SEWAGE DISPOSAL SYSTEM

DEPARTMENT OF HEALTH AND MENTAL HYGIENE

SUBDIVISION Fulton Estates LOT 8 ROAD 12130 Fulton Estates Court

Memo To The File

INDICATE NORTH - NAME ADJOINING ROADWAY AS BASE LINE

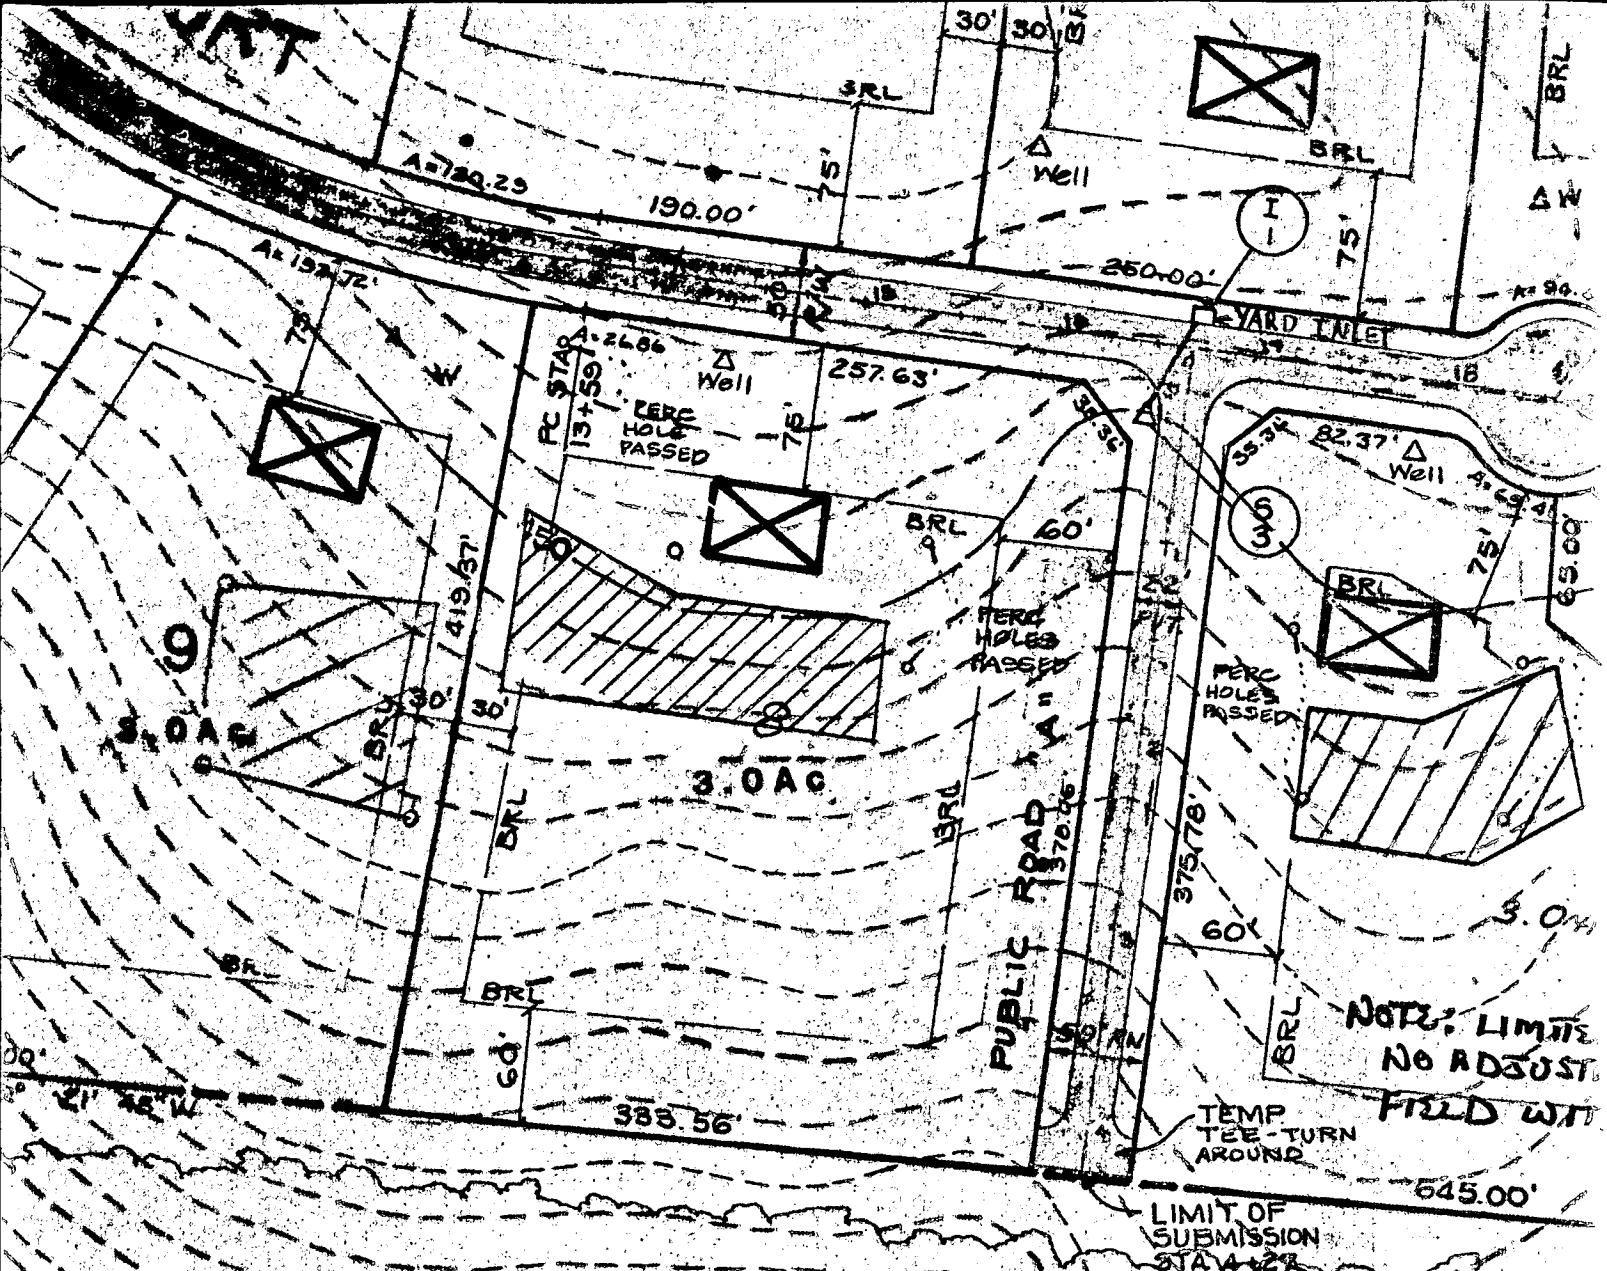
REMARKS: 1/21/91 PROPOSED LOCATION OK R/Hodges
1/22/91 11AM - TRENCHES #1 & #2 DUG ADD STONE 1/22/91 OK TO COVER TRENCH #2
& HOUSE SEWER DIG TRENCH #3 ADD STONE TO TRENCH #1. HOUSE HAS 5 BR. RH
& 120. ALSO PRESENT. 1-23-91 OK to finish stoning & cover trenches and all
WORK. JEN

12130 Fulton Estates Court
Fulton Estates Lot-8

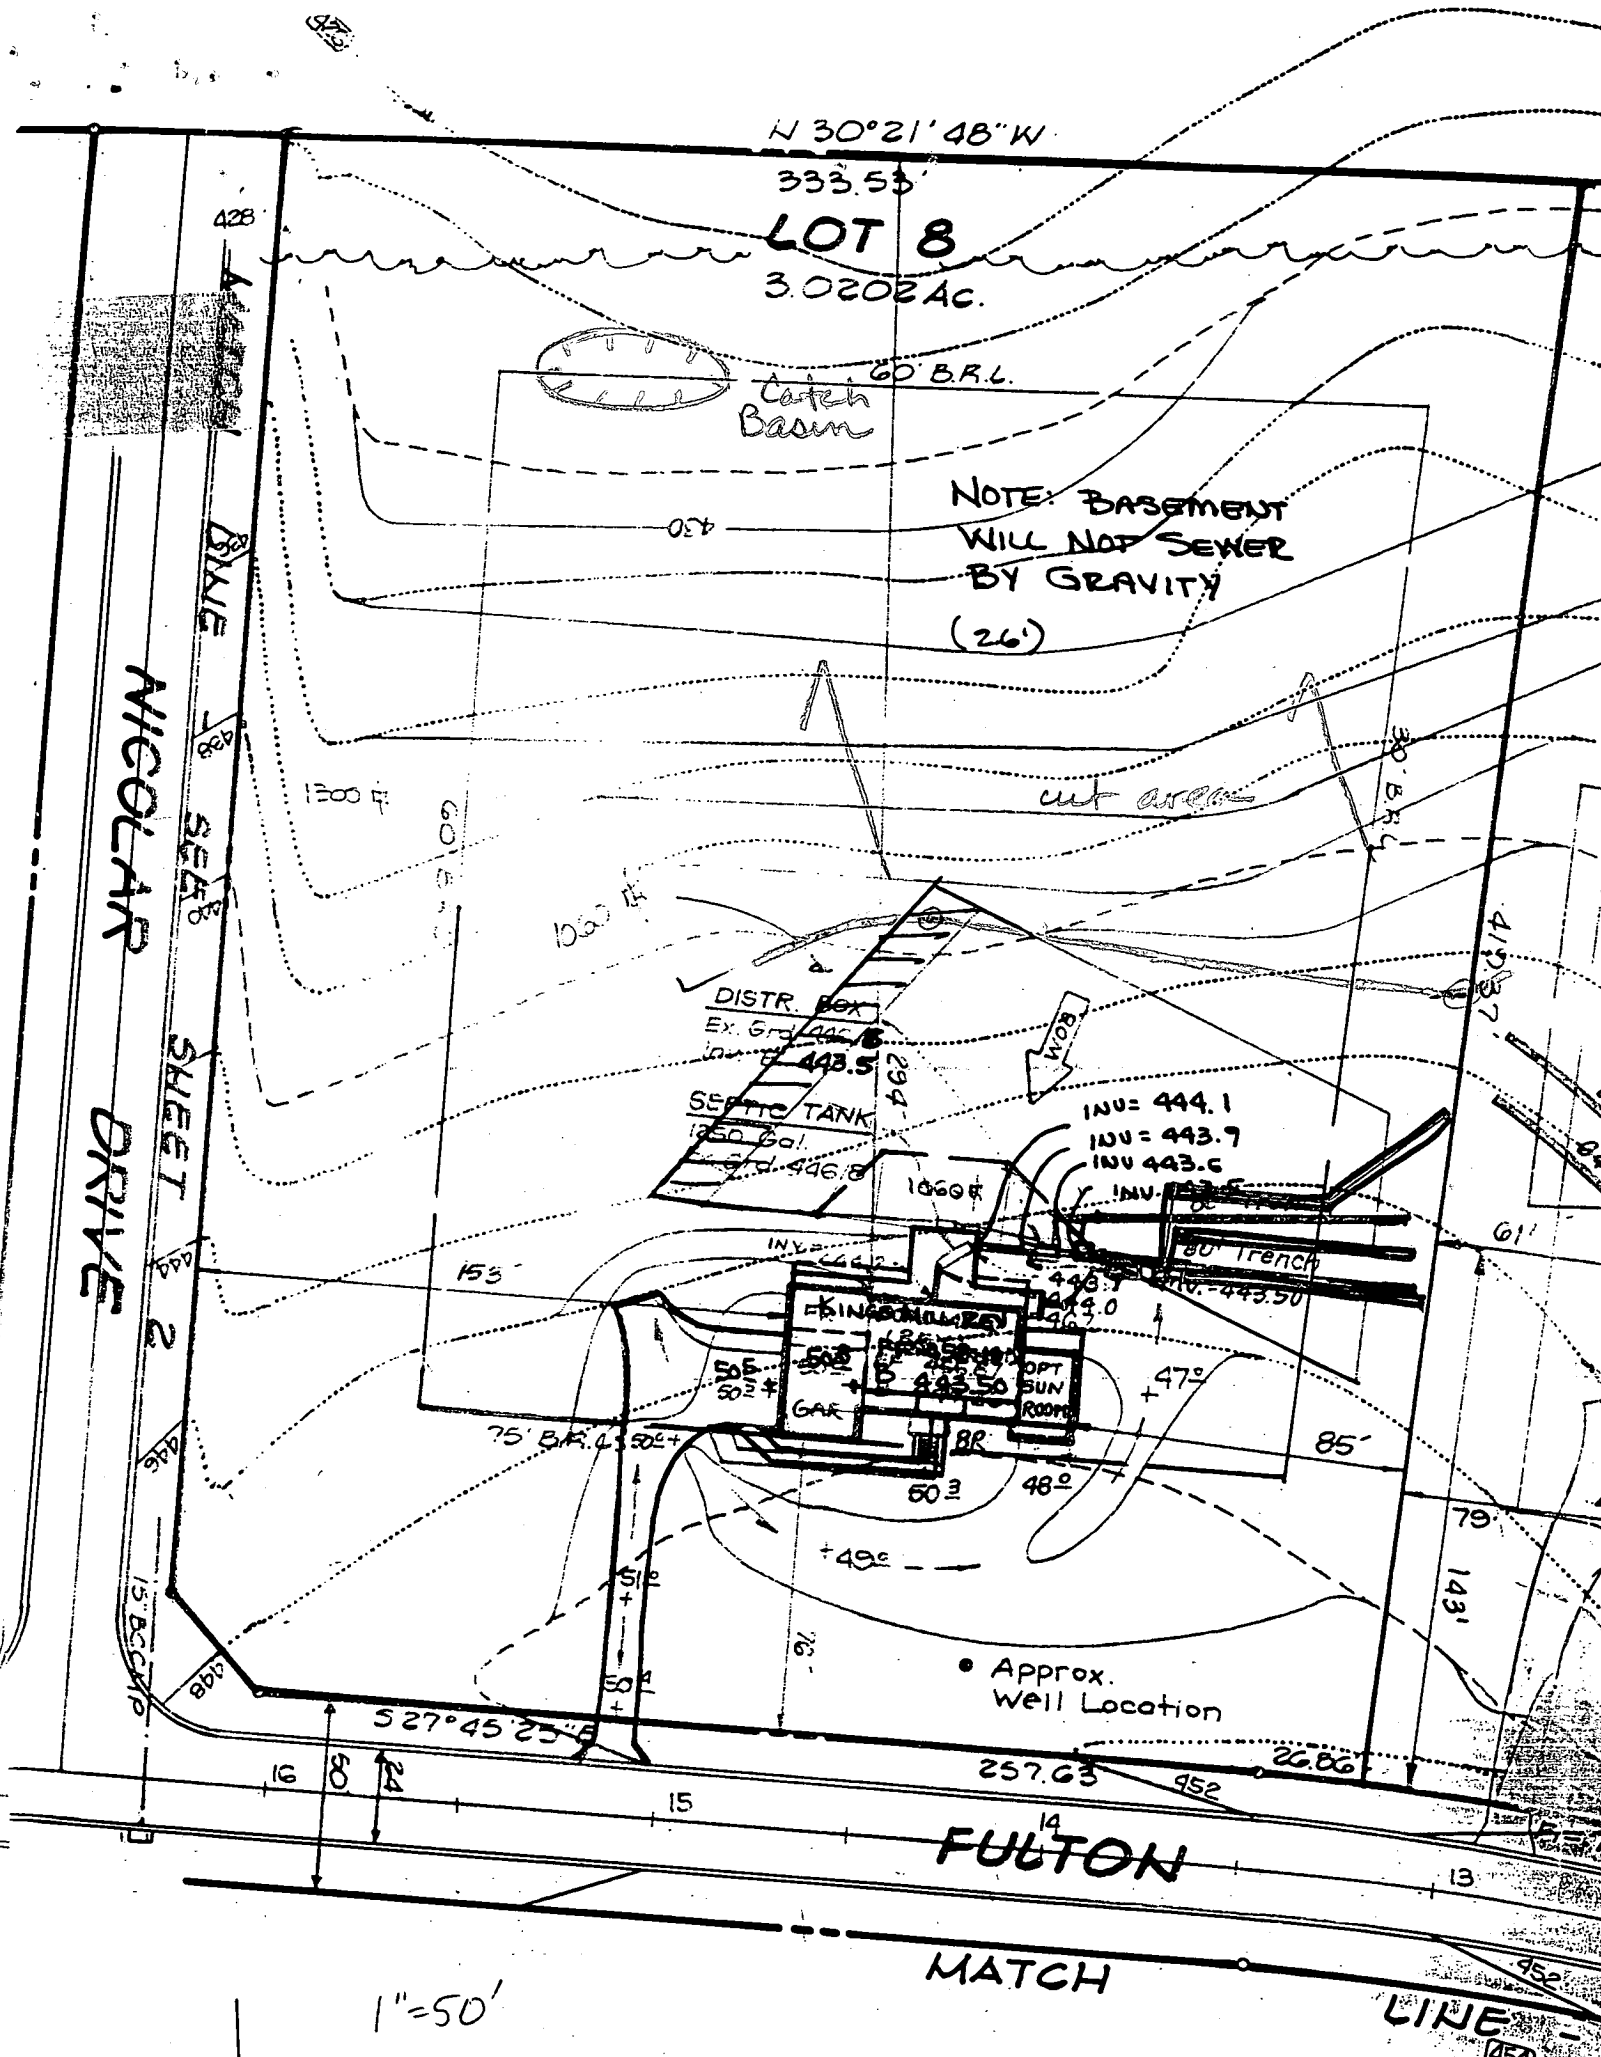
During a final septic inspection on January 23, 1991 a cut in grade was observed adjacent and directly downhill of the sewage disposal easement. The cut appears to be some sort of storm water management containment basin.

As far as I can determine, no mention of this grade change was ever brought to the attention of the Health Department. My concern is that after a future repair has been completed, there may be some sewage leachate that breaks out of the man-made slope adjacent to the septic easement.

The slope appears to be 15% to 20% grade, approximately 80 feet below the family room portion of the house.

See enclosed drawing for approximate location.
